To: Plan Holders for Improvements to the
KIRKSVILLE REGIONAL AIRPORT
KIRKSVILLE, MISSOURI
MODOT PROJECT NO. 24-028A-1

Transmitted herewith is Addendum **No. 4** to the Issued for Bid Contract Documents, Specifications and Plans dated May 30, 2024 for Improvements to the IRK Airport.

**ADDENDUM NO. 4
TO
CONTRACT DOCUMENTS, SPECIFICATIONS AND PLANS
FOR IMPROVEMENTS TO THE
KIRKSVILLE REGIONAL AIRPORT
KIRKSVILLE, MISSOURI
MODOT PROJECT NO. 24-028A-1**

SHEET NAME:
LIFE SAFETY PLAN AND
CODE SUMMARY

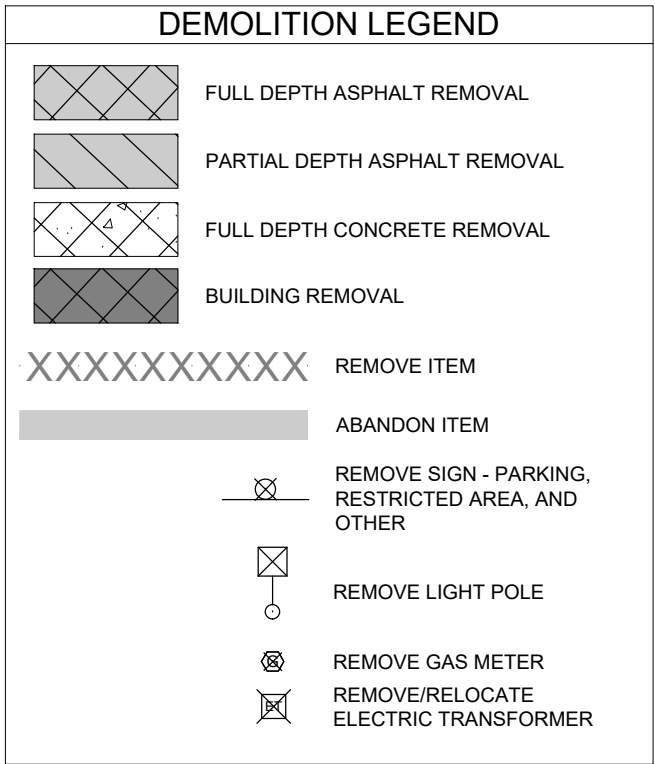
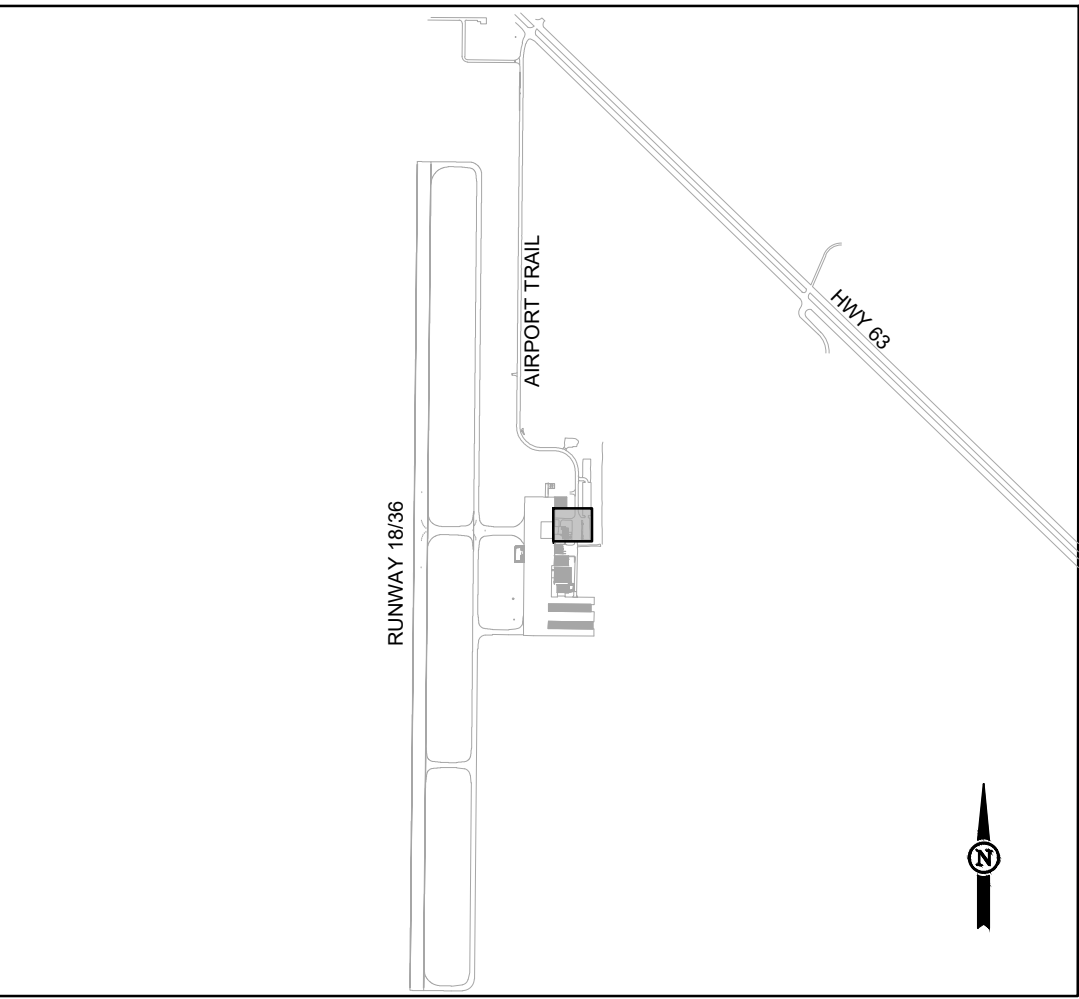
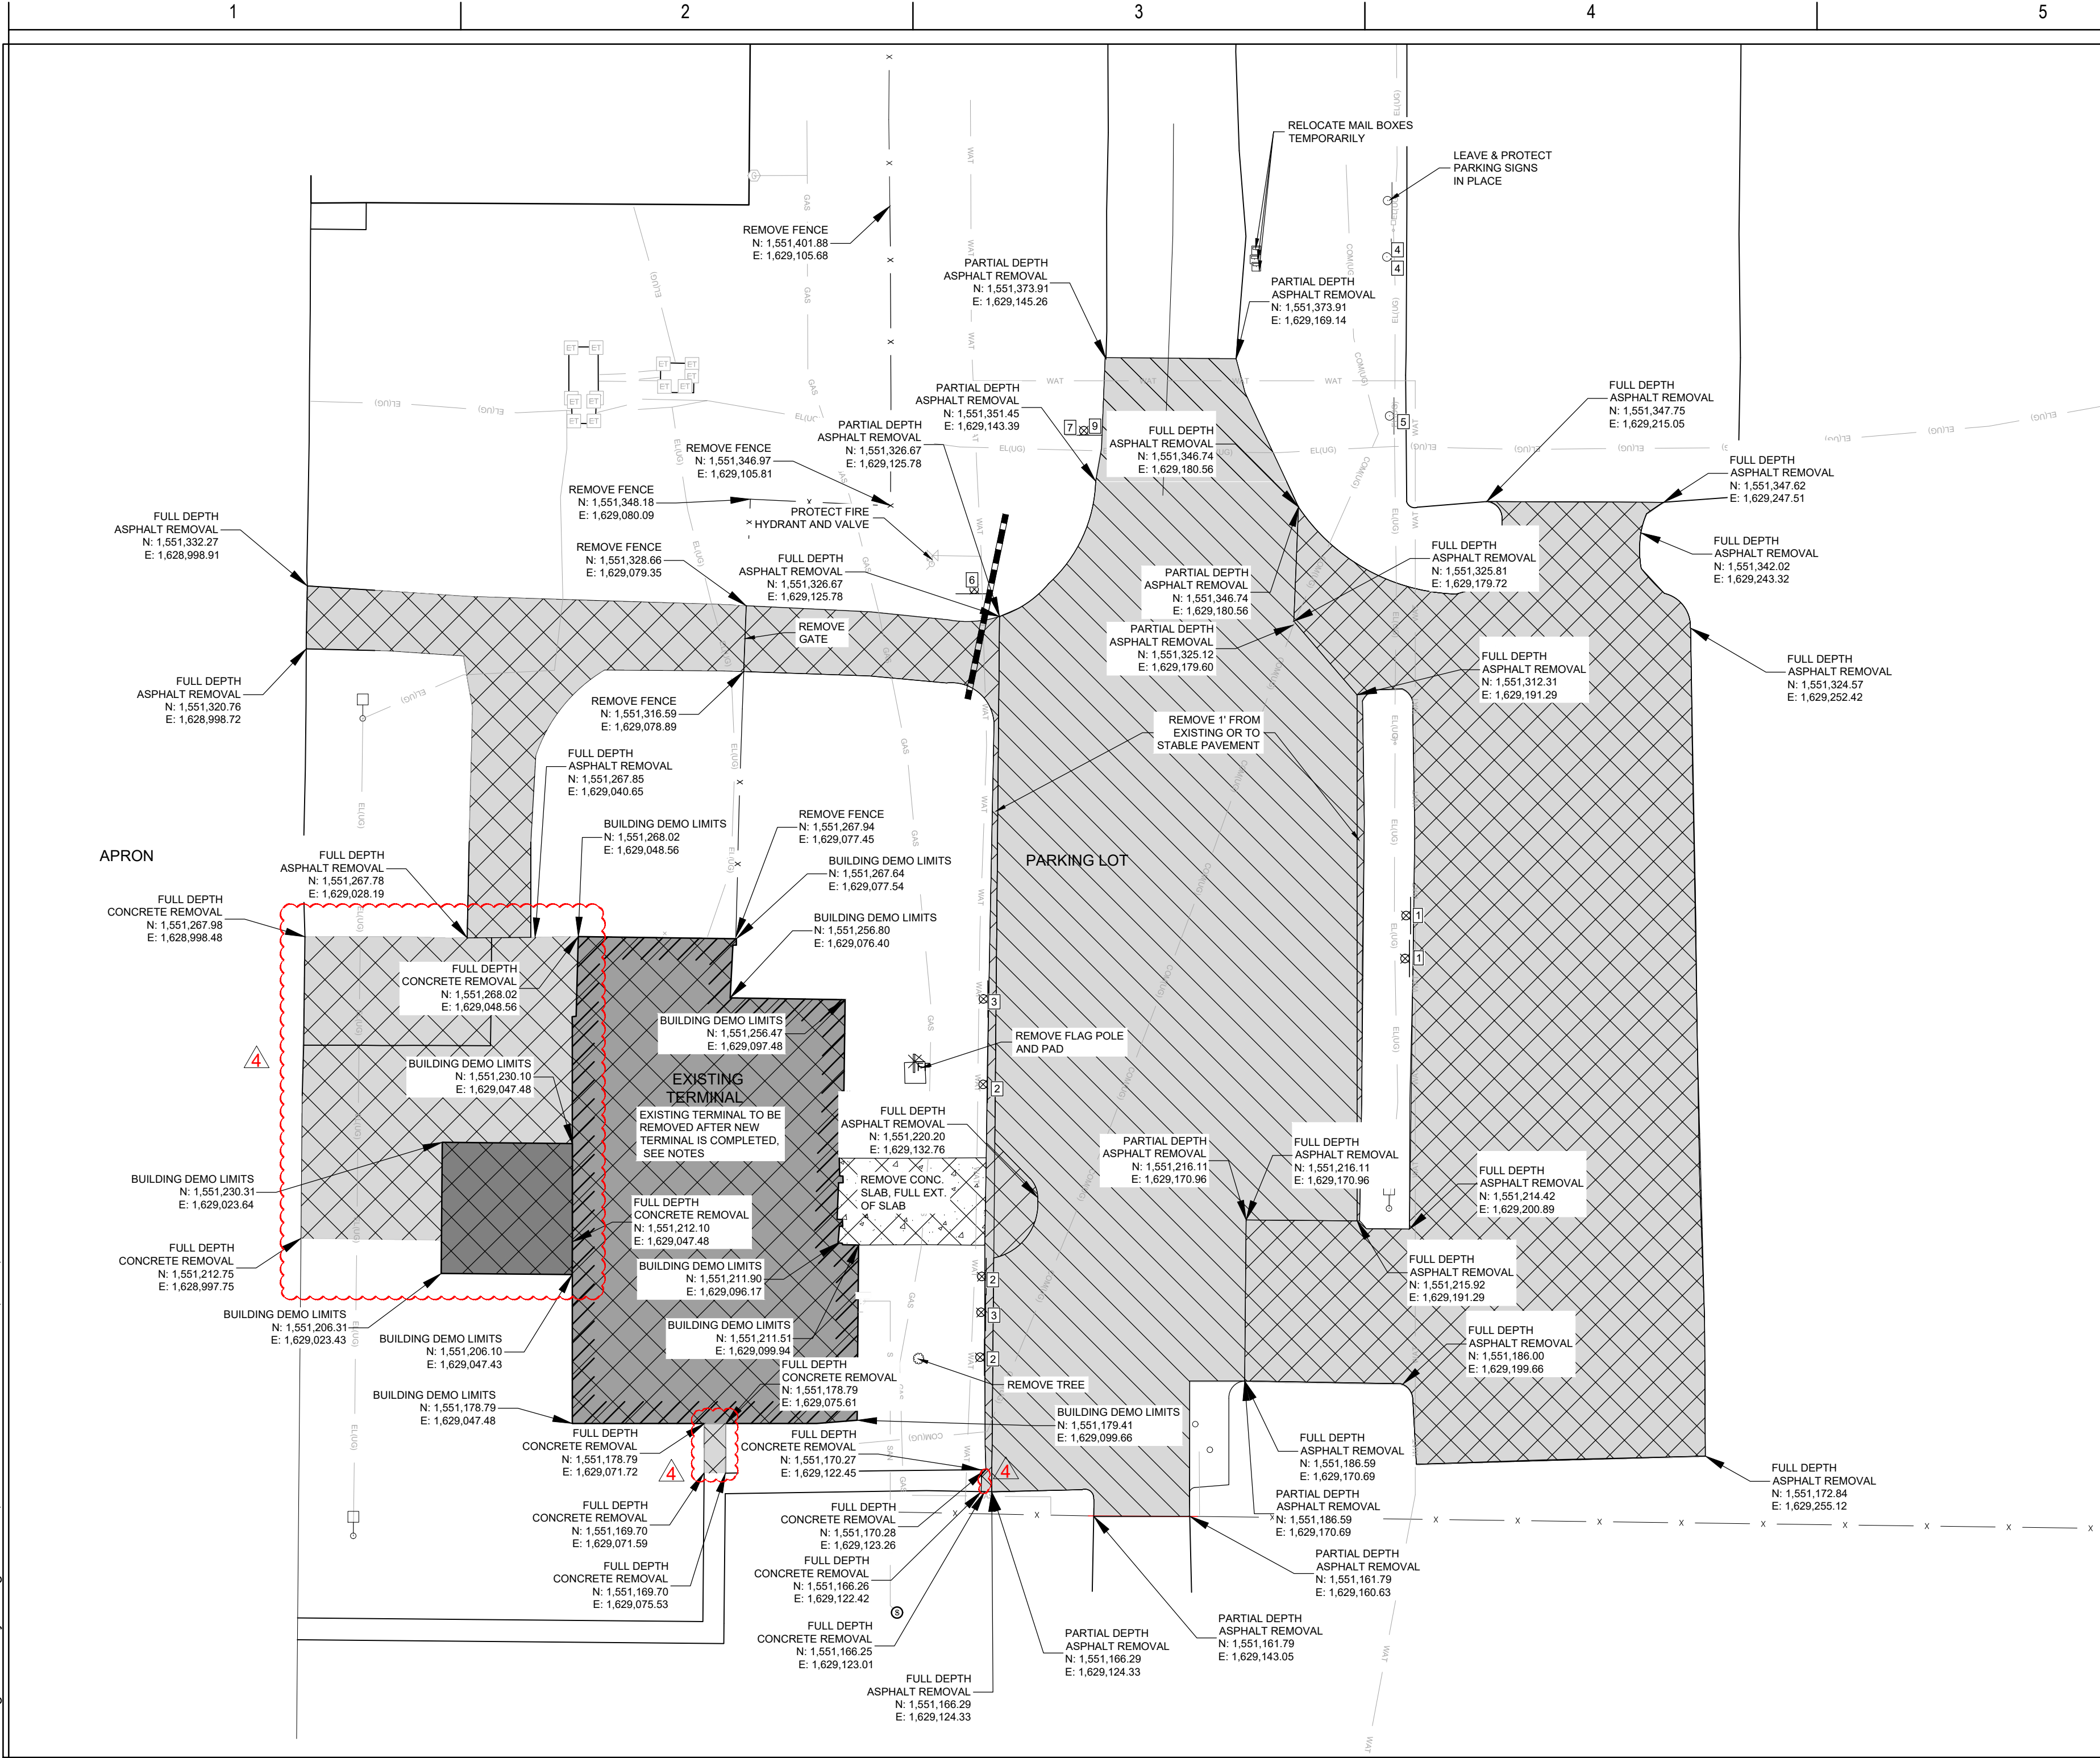
1. *Sheet A-702 mentions items such as Corner Guards but we failed to see any Fire Extinguisher Cabinets.*

17. *On door schedule sheet A601 it is showing 45 MIN. rating on all doors? Automatic sliding doors will not be fire rated. If aluminum swing doors need to be fire rated, this can be done BUT I will not be able to get a price on those by bid date. Also exterior curtain wall calling out champagne and black anodized on interior. (spec says exterior frames sf-3 & sf-6 black anodized as well) Is this correct on black frames?*

Response: Refer to A-701 and A-702 for corner guard locations. The fire extinguishing cabinets are located in the Life Safety Plan on sheet G-002 of the bid documents.

Response: Fire ratings have been clarified on sheet G-002. The only wall that shall receive a fire rated gyp is the north wall of the TSA Offices, IT Room, and Storage Room. Door 121 is the only door that requires 45 minute fire rating. Refer to A-601.

SHEET NAME:
FOUNDATION PLAN

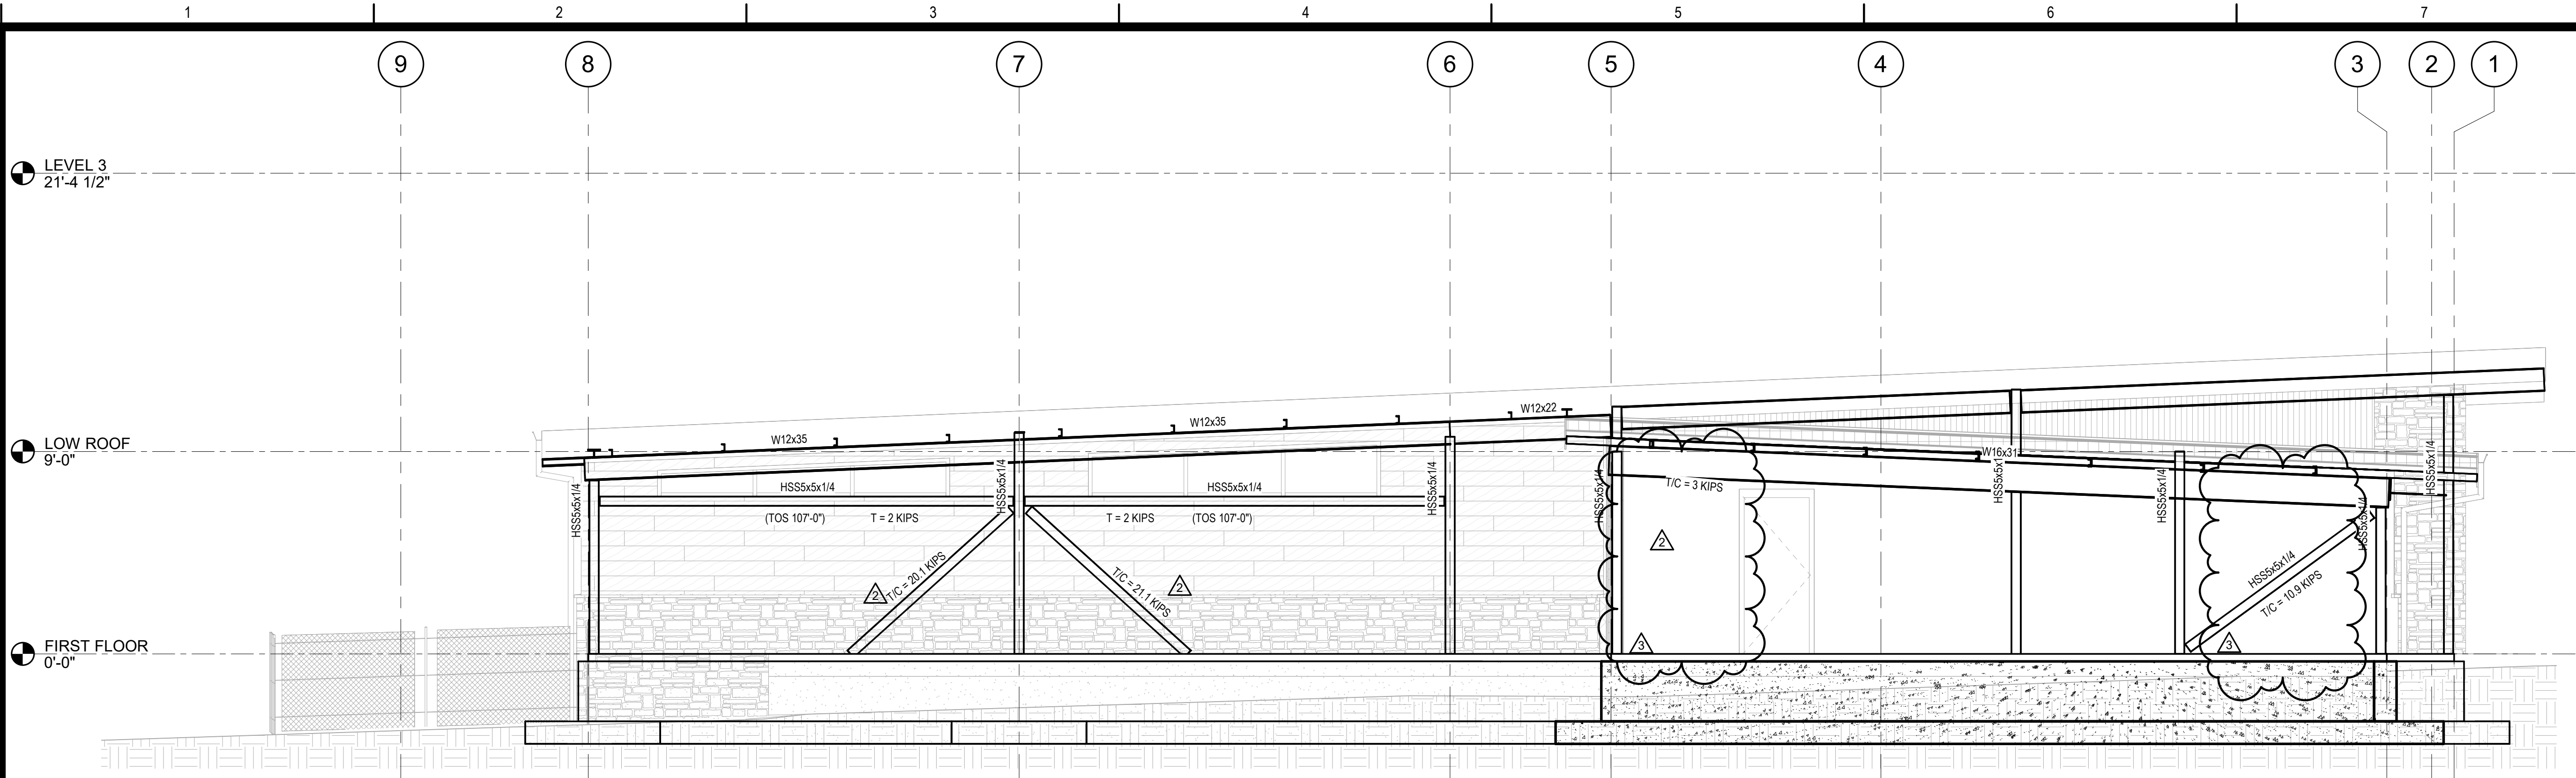
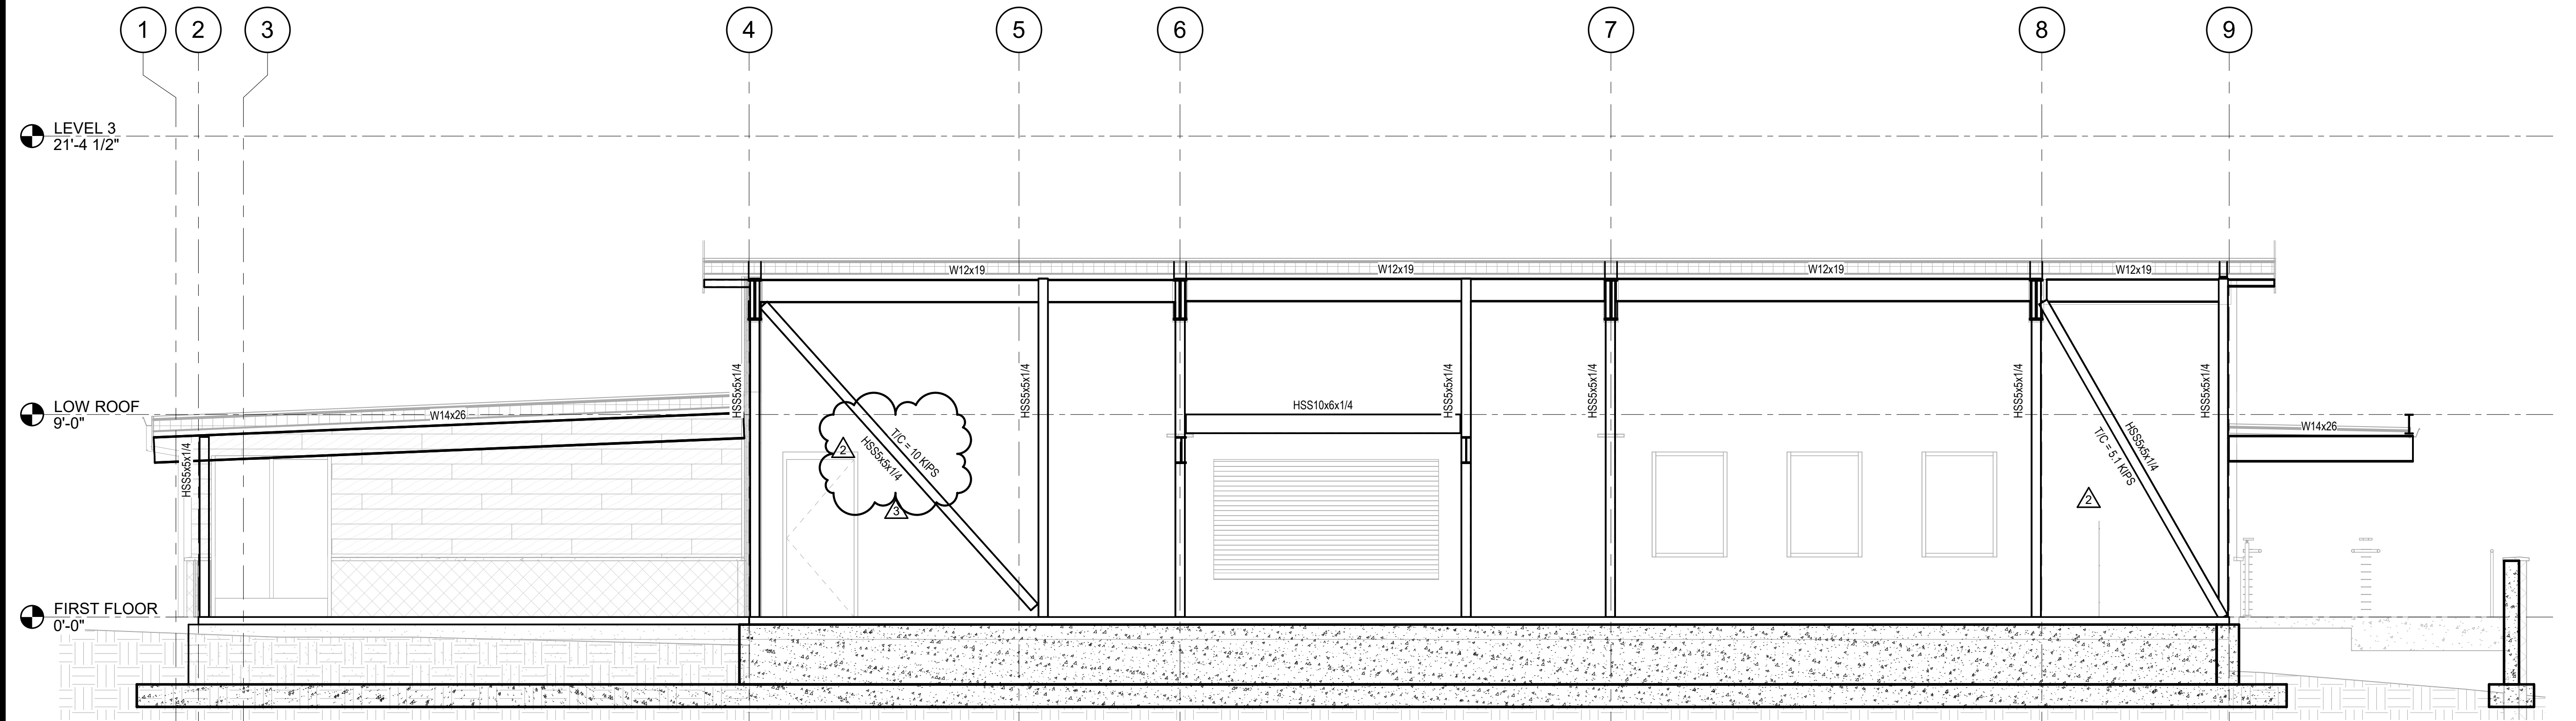
4. *Sheet S-100 Foundation Plan calls for wall footing WF-24. What are the dimensions? We assumed 24" x 12".*

5. *Sheet S-100 Foundation Plan calls out for a variety of column footing pads. What are the dimensions? We assumed F-6.0 is 6'-0" x 6'-0" x 1'-6". F5.0 is 5'-0" x 5'-0" x 1'-3". F4.0 is 4'-0" x 4'-0" x 1'-0".*

7. *Sheet S-200 Detail 2 states concrete stem wall. What is the thickness of the wall? We assumed a 12" thick wall.*

8. *Sheet S-200 Detail 2 indicates a footing schedule. We did not find one.*

Response: Refer to S-100.

Response: Refer to S-100.

Response: Refer to S-100.

Response: Refer to S-100.
